**From:** [Schofer, Fred](#)  
**To:** [Algama, Don](#); [Esmaili, Hossein](#); [Helton, Donald](#); [Murphy, Andrew](#); [Nosek, Andrew](#); [Pires, Jose](#); [Compton, Keith](#); [Barto, Andrew](#); [Wagner, Brian](#); [Chang, James](#); [Armstrong, Kenneth](#); [Lee, Richard](#); [Witt, Kevin](#); [Helton, Shana](#); [Reckley, William](#); [Jones, Steve](#); [Casto, Greg](#)  
**Subject:** Comment resolution matrix for use during today's discussion of RES comments on the Tier 3 Regulatory Analysis  
**Date:** Tuesday, September 10, 2013 10:53:17 AM  
**Attachments:** [Reg Analysis\\_rA Comment Resolution Matrix.xlsx](#)

Regulatory Analysis, Rev. A Comment Resolution Matrix

**Compiled Comments on Frozen SFPSS Documents**  
(Comments in black, helpful info in blue)

Figure 4 Comparison of annual PGA exceedance frequencies for U.S. Mark I reactors (USGS 2008 model) (rock hazard curves)

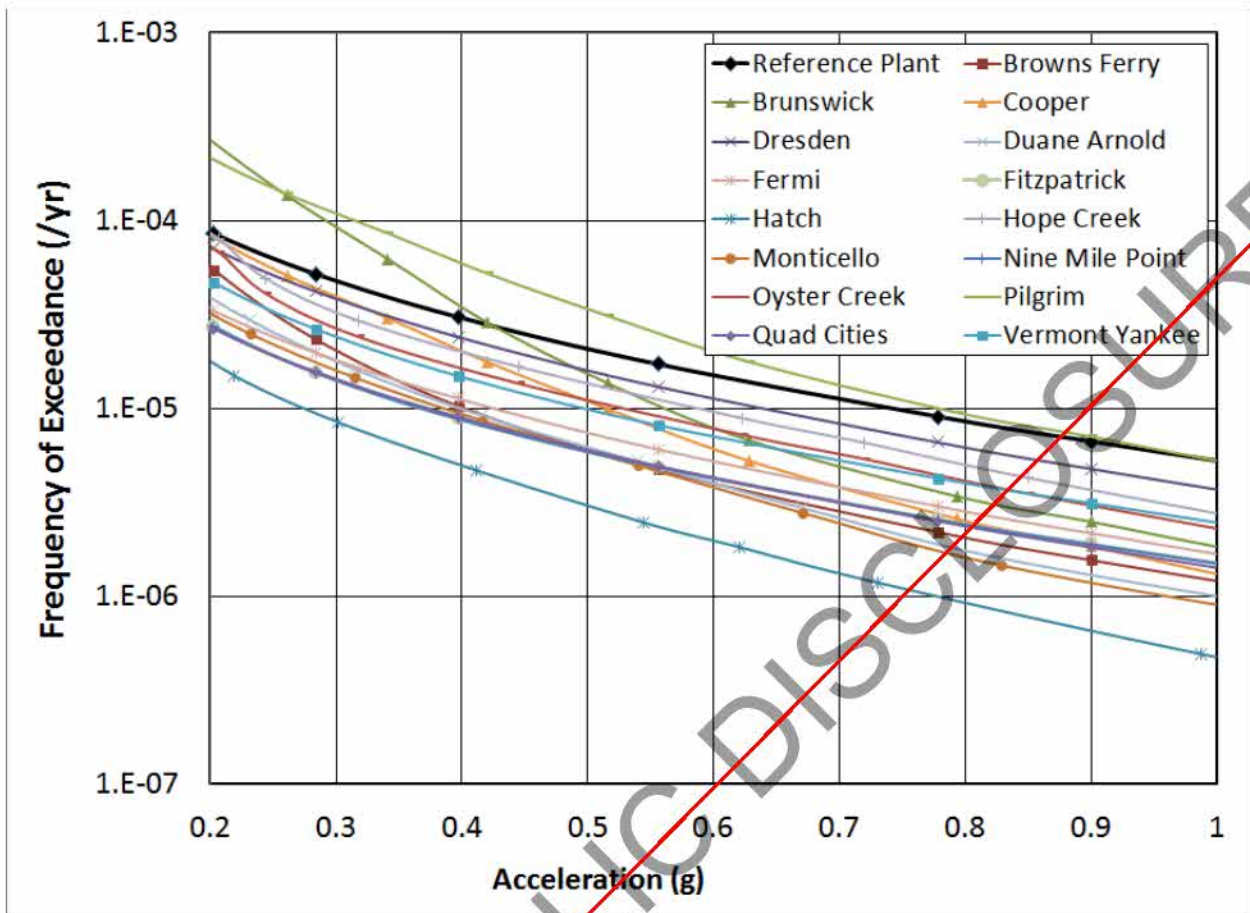
383	NRO	03.29.13	Pg31	Theresa Clark	<p>Section 3.1 (page 31, Figures 4 and 5) should indicate in the figure captions that these are hard rock hazard curves</p>	Jose P.	<p>Response: The captions have been modified to address the comment.</p>		Closed	DivDir Concurrence	--
384	NRO	03.29.13	Pg33	Theresa Clark	<p>Section 3.2 (page 33, last paragraph) includes this statement: "In addition to the PGA, ground motions at a site are also characterized by their frequency content expressed in terms of response spectra. Based on the USGS 2008 model, a uniform hazard site Ground Motion Response Spectrum (GMRS) (NRC, 2007b) was derived for the GI-199 study and used in this study." It is incorrect to combine the term uniform hazard response spectra with the term GMRS. In addition, Footnote 5 states that "the term GMRS has a specific meaning in the context of Regulatory Guide (RG) 1.208 (NRC, 2007b). In this report, the term GMRS is used more generally." The report should describe how the response spectrum for the selected site was developed. If it is not consistent with the definition of the GMRS in RG 1.208, then use a different name. Clarify whether the response spectrum for the reference site shown in Figure 7 is a uniform hazard response spectrum. In addition, do a global search for "GMRS" because it is used throughout the report.</p>	Jose P.	<p>Response: The footnote has been deleted. After further examination, it was confirmed that the GMRS in the report is based on the guidance in Regulatory Guide 1.208 used in conjunction with USGS (2008) model. This is clearly noted in the report and repeated often. Use of a different hazard model and maybe a more detailed analysis might produce a somewhat different GMRS. We do not think that the footnote is needed because the assumptions are clearly indicated. Also, as per the response to the comment related to the use of the USGS (2008) model (comment 379) we prefer not to make references to licensing review aspects in a study of this type.</p> <p>Nevertheless, when referring to the GMRS, the text in the report will be modified to replace "site GMRS" with "reference GMRS." Also, the text at the end of Section 3.2 and after Table 5 will be modified to read:</p> <p>In addition to the PGA, ground motions at a site are also characterized</p>		Closed	DivDir Concurrence	--

892	OGC	05.23.13	37	Tison Campbell	Figure 4 Comparison of annual PGA exceedance frequencies for U.S. Suggest updating the figure to identify the reference site as a reminder to readers	Jose P.	Figure was updated and the legend now says "Reference Plant" instead of Peach Bottom.		Closed	OD Concurrence	
893	OGC	05.23.13	37	Tison Campbell	Figure 5 Comparison of annual exceedance frequencies for 1 Hz spectral accelerations for U.S. Mark I reactors (USGS 2008 model) (rock hazard curves) Suggest updating the figure to identify the reference site to readers	Jose P.	Figure was updated and the legend now says "Reference Plant" instead of Peach Bottom.		Closed	OD Concurrence	
894	OGC	05.23.13	39	Tison Campbell	bin 3, with initiating annual frequencies on the order of $1 \times 10^{-5}$ to $2 \times 10^{-5}$ , have the potential of challenging the structural integrity Why not just say "could challenge"?	Jose P.	Suggested edits made.		Closed	OD Concurrence
